UNITED STATES PATENT AND TRADEMARK OFFICE

10/505,206

COLILLA, DANIEL JAMES

Office Action Summary

【 5 】

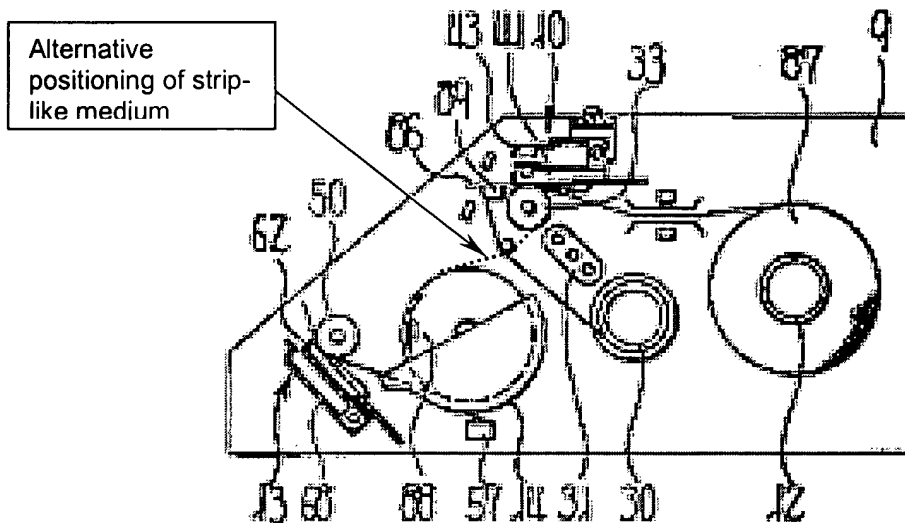
With respect to claim 1, Iida discloses a printer module with a base plate 9,20 which has a mounting area for a first unwinding bearing 12 which holds a first supply roll 87 of a strip-like medium and a mounting for a first printing mechanism which includes a transport roll 33, a rotary drive 38 and a print head 41 opposite the transport roll 33 as shown in Figure 5 of Iida. The base plate 9,20 further has a mounting area for a second unwinding bearing 14, a second supply roll 88 of a strip-like medium and a mounting area for a second printing mechanism which includes a transport roll 50, a rotary drive 58 and a printhead 62 opposite the transport roll 50 as shown in Figure 5 of Iida.

With respect to claim 3, the second unwinding bearing 14 is in a position from which the strip-like medium 88 can be guided optionally either to the first printing mechanism as shown below in the Figure taken from Figure 5 of Iida or to the second mechanism as shown in Figure 5.
